Re: Objections to Brook Mining Co., LLC Coal Mining Permit Application

On behalf of the members of the Powder River Basin Resource Council ("Resource Council"), our organization hereby submits these objections to the proposed coal mining permit for Brook Mining Co., LLC ("company" or "applicant") in Sheridan County.

FIGURE 4.3 PLANNED TRENCH AND COAL BLOCK AREAS WITH FAULTS AND CROSS SECTION LINES

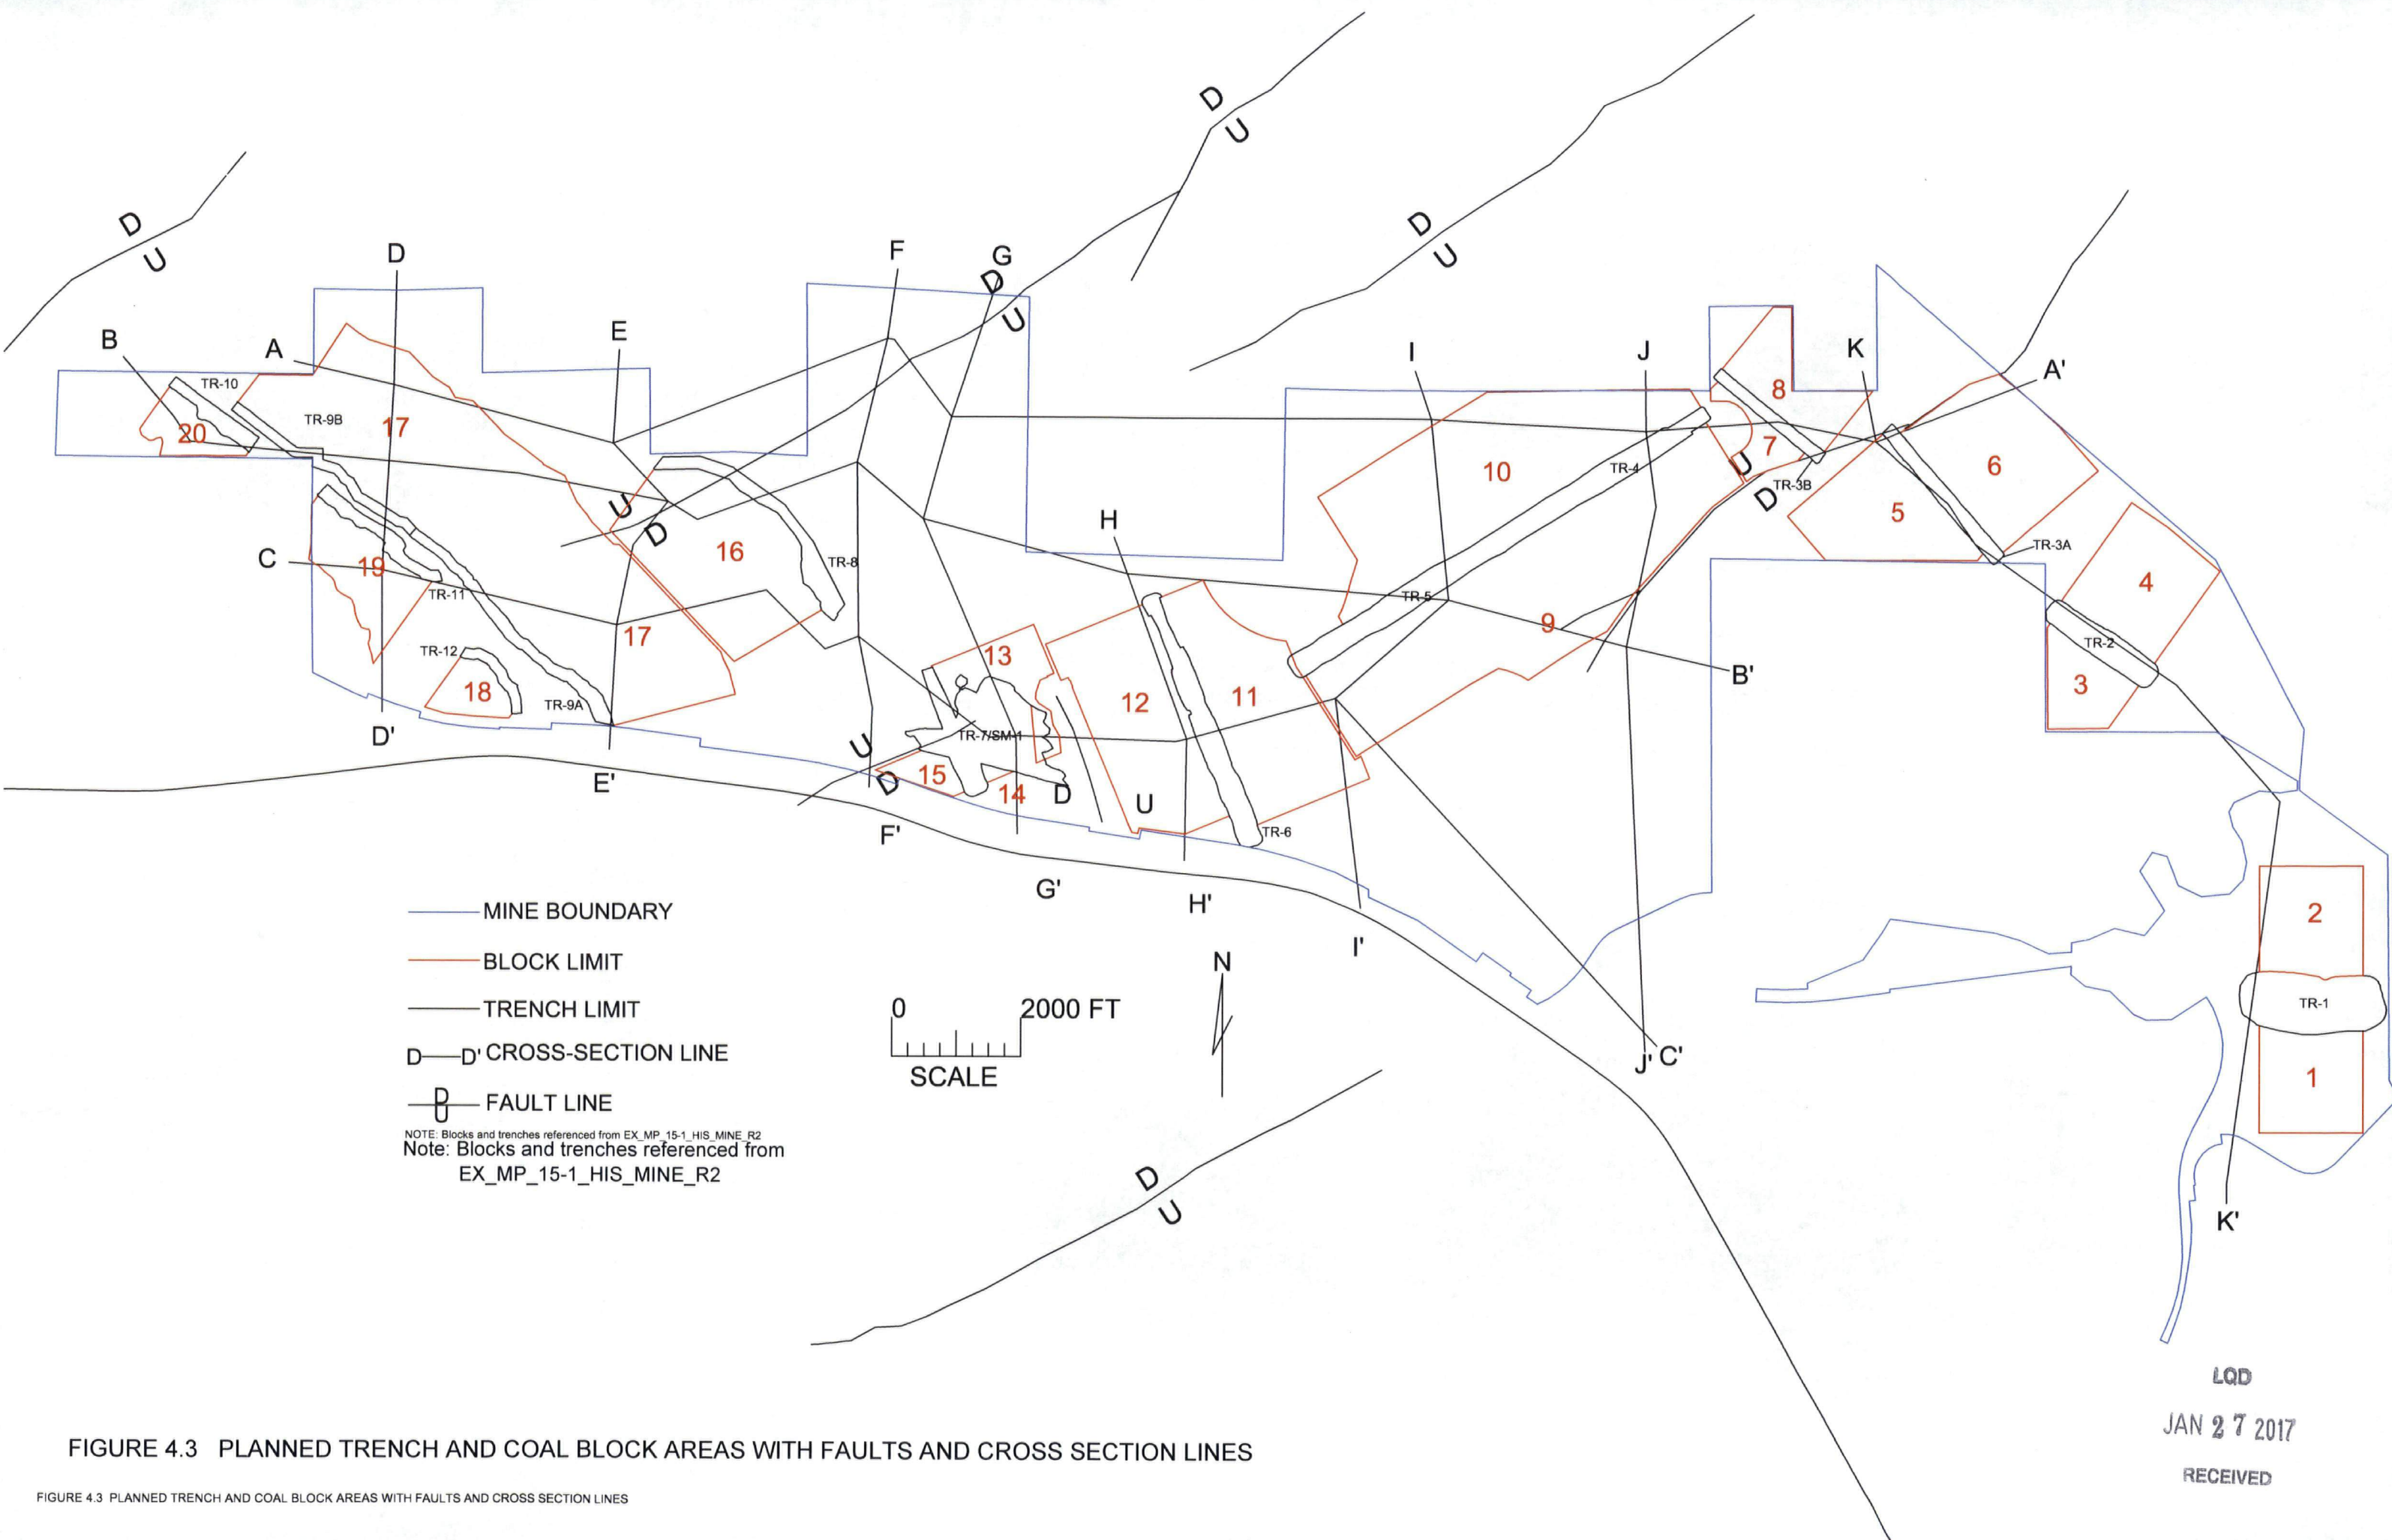
In order to better understand the ground conditions in the areas of proposed mining, the mining layout given in Figure 4.3 has been superimposed over the various isopach exhibits for the Carney and Masters seams provided in the mine application. These drawings are shown in Figures 4.5 to 4.12. Also, the mine block areas had been delineated on the various geologic cross-sections drawn by Ramaco across the site (see Figure 4.3). The modified cross-sections showing the mine block locations are shown in Figures 4.13 to 4.24. From this reported information, the Dietz, Monarch, Carney, and Masters related conditions per block have been summarized in Table 4.1.

There is no governing roof and floor design criteria on what will dictate the barrier and web pillar width and spacing, and panel width to avoid complete overburden instability, based on the variable ground/mining conditions which may be encountered (see Figure 5.1). This is especially problematic given the reported very poor roof and floor consisting mostly of claystone although resistance augmented siltstone and sandstone zones exist there locally (see Figure 4.13 to 4.24).

FIGURE 4.4 PROPOSED HIGHWALL MINING AND PILLAR CONFIGURATION (SEE P. MP-F3)

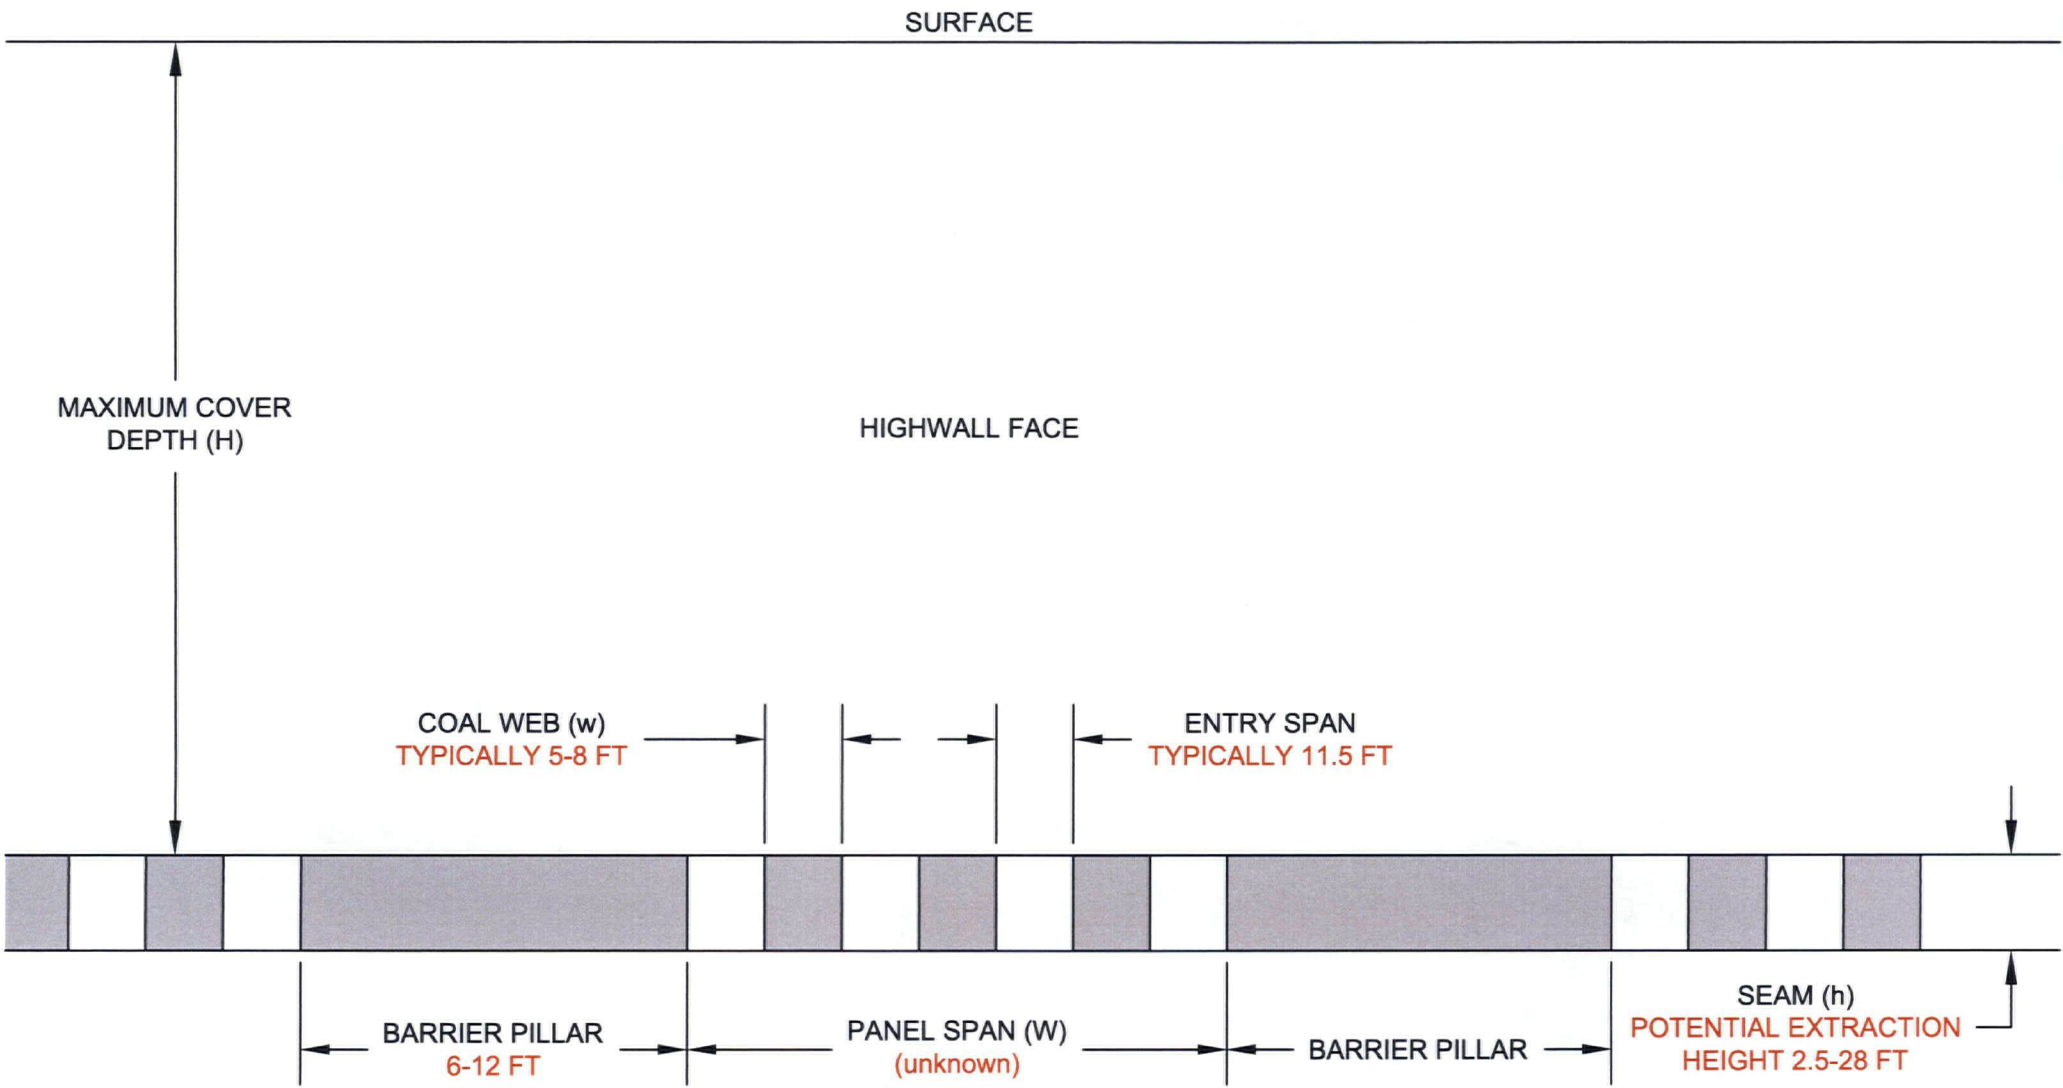
The proposed room and pillar configuration is depicted in Figure 4.4. As can be seen in Figure 4.4, there is no definitive geometry stipulated in the application as much of the identified dimensions are qualified. Using the "typical" web pillar widths and room width, the panel extraction ratio would vary from 59% to 70% in the panels.
